STAFF REPORT
Young World Plat
104-MP-83

SUBJECT: Delegation Request: Modify Conditions of Plat Approval
(Amendment to Non-Vehicular Access Line)
Young World Plat (104-MP-83)

Title of Request NVAL amendment for four openings due to Redevelopment

**SKETCH AND DESCRIPTION
& NOVA SOUTHEASTERN UNIVERSITY PROPOSED NON-VEHICULAR ACCESS LINE
EXHIBIT "C"**

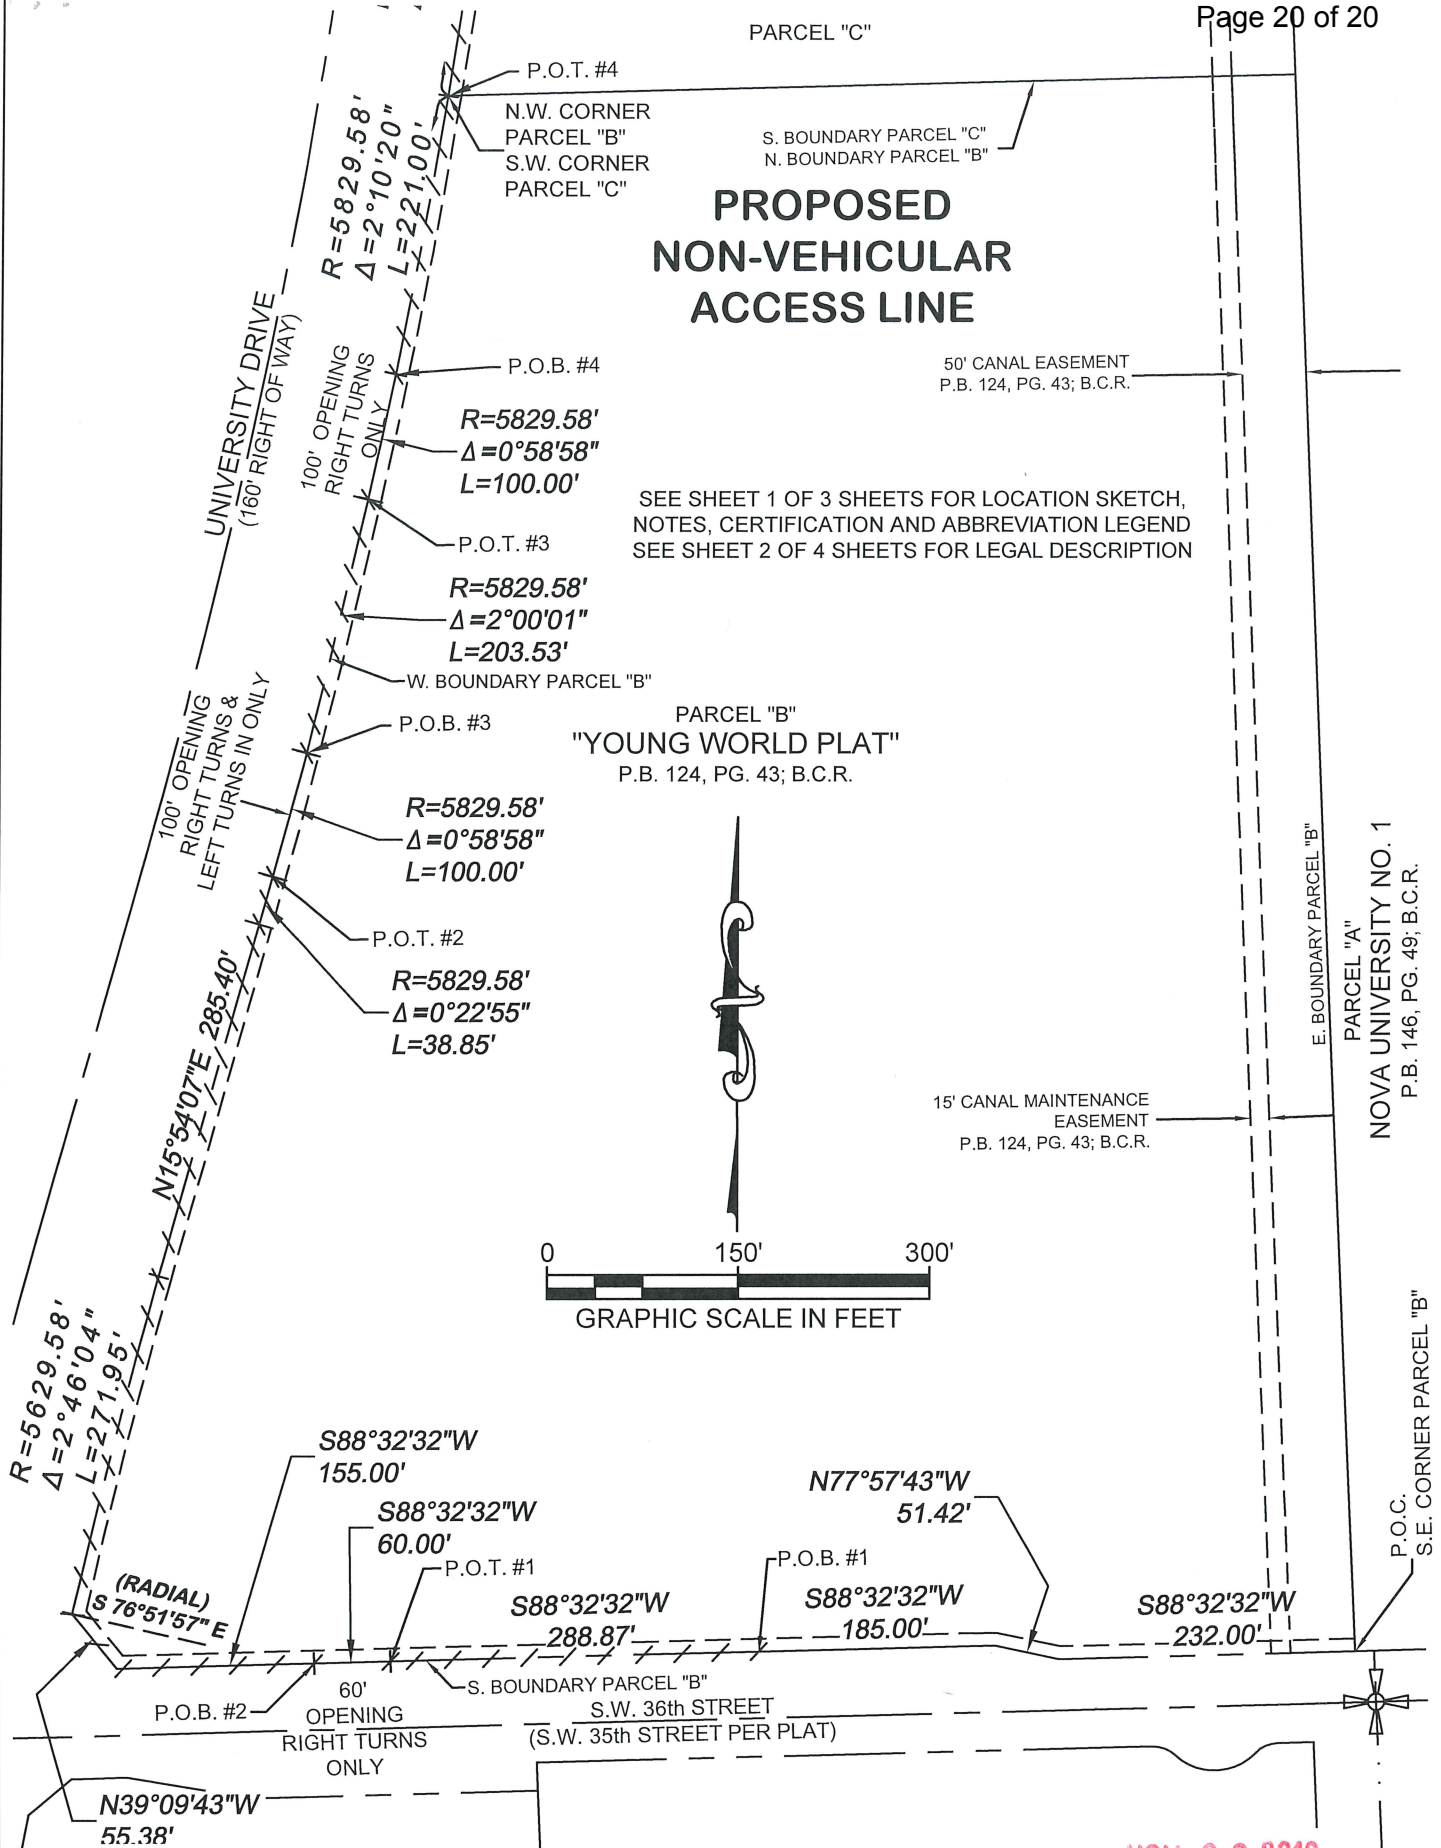
The applicant is requesting to amend the non-vehicular access line as follows:

- Move the point of beginning along the S boundary line of Parcel “B” to 468.42 feet west of the southeast corner of Parcel B.
- Delete the 50-foot opening along South University Drive centered approximately 450 feet north of the southwest corner of Parcel B.
- Create a 100-foot opening along South University Drive centered approximately 650 feet north of the southwest corner of Parcel B.

5. Exhibit "C" to the NVAL Amendment Agreement shall describe and illustrate a new non-vehicular access line along University Drive adjacent to the plat except at the following openings:
 - a. A 100-foot opening centered approximately 646 feet north of the corner chord at the intersection of University Drive and SW 36th Street. This opening shall be labeled on Exhibit C: LEFT TURNS IN AND RIGHT TURNS ONLY.

- b. The existing 100-foot opening centered approximately 950 feet north of the corner chord at the intersection of University Drive and SW 36th Street. This opening shall be labeled on Exhibit C: RIGHT TURNS ONLY.
